Nuclear Fuel Services, Inc.
P.O. Box 337, MS 123
Erwin, TN 37650

**Subject: License Amendment Request to Remove Sampling Requirements
for Banner Spring Branch**

Nuclear Fuel Services, Inc. (NFS) hereby requests an amendment to the referenced license to authorize the removal of Banner Spring Branch sampling requirements. This request is being made because Banner Spring Branch has been relocated and enclosed inside a pipe. The relocation and total enclosure of Banner Spring Branch in a concrete culvert eliminated the silt deposits, and thus the upstream and downstream silt collection points. Access to Banner Spring Branch waters is limited due to the encapsulation of the stream in a concrete pipe. The upstream water collection point has also been eliminated. This change has removed the potential for release of radioactive materials due to decommissioning activities. Additionally, Banner Spring Branch does not have the potential for release of radioactive materials from process effluent, because the noncontact cooling water loop for Building 233 no longer exists. The only inflow into Banner Spring Branch is storm water runoff, which is maintained in accordance with NPDES Permit No.

FIGURE 13.1
SITE GROUNDWATER MONITORING WELL LOCATIONS

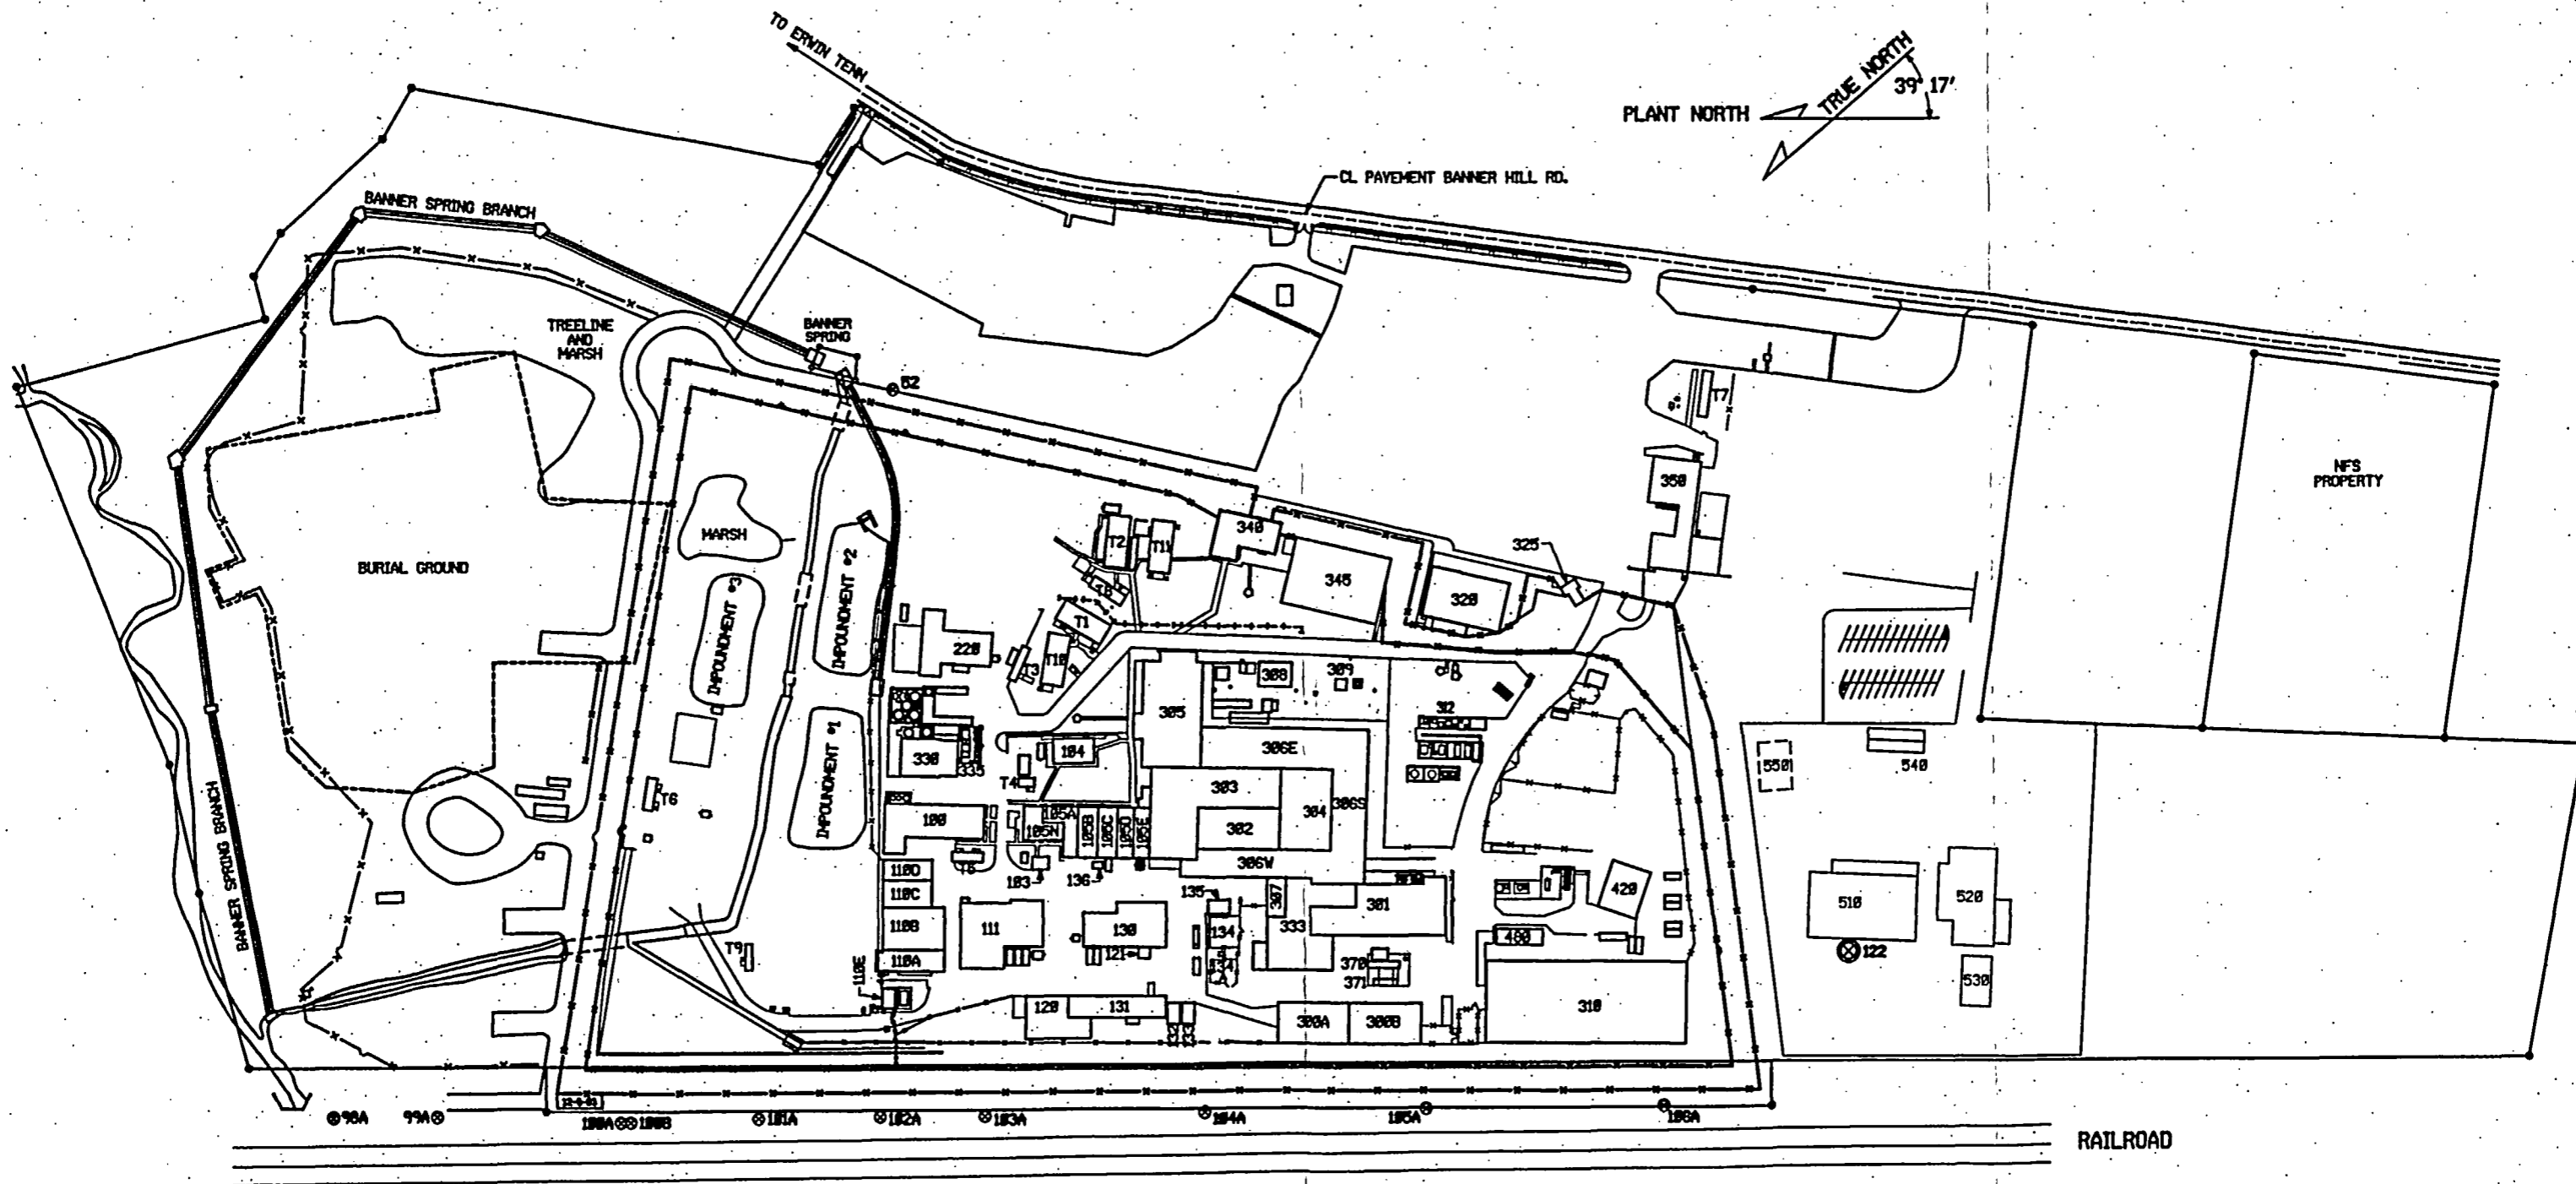
TOLEANCE UNLESS SPECIFIED		NES		NUCLEAR FUEL SERVICES, INC. EVAN, TENNESSEE	
ADDED NEW LOCATION OF BANNER SPRING BRANCH		A		REVISION BY: <i>[Signature]</i>		SNM-124 GROUNDWATER MONITORING PROGRAM MONITORING WELL LOCATIONS	
DATE	02-19-02	REVISION	ORIGINAL ISSUE	ANGULAR	± 1/2"	PROPOSED APPROVALS	DATE 02-20-04
BY		LET		DECIMAL	± 1/32"	SCALE 1" = 200'	005-C0132-B1
THIS DRAWING, INCLUDING ALL INFORMATION CONTAINED HEREIN, IS THE PROPERTY OF NUCLEAR FUEL SERVICES, INC. (NFS). THIS DRAWING IS LOANED SUBJECT TO RETURN ON DEMAND AND IS NOT TO BE COPIED, REPRODUCED, TRANSMITTED, OR DISCLOSED IN WHOLE OR IN PART TO THIRD PARTIES WITHOUT PRIOR WRITTEN CONSENT OF NFS.				DRAFTER: <i>[Signature]</i>		SCALE 1" = 200'	
				CHECKED: <i>[Signature]</i>		DATE 02-20-04	
				APPROVED: <i>[Signature]</i>		DRAWING NO. 005-C0132-B1	
				DATE 02-20-04		CONFIGURATION CONTROL YES <input type="checkbox"/> NO <input checked="" type="checkbox"/>
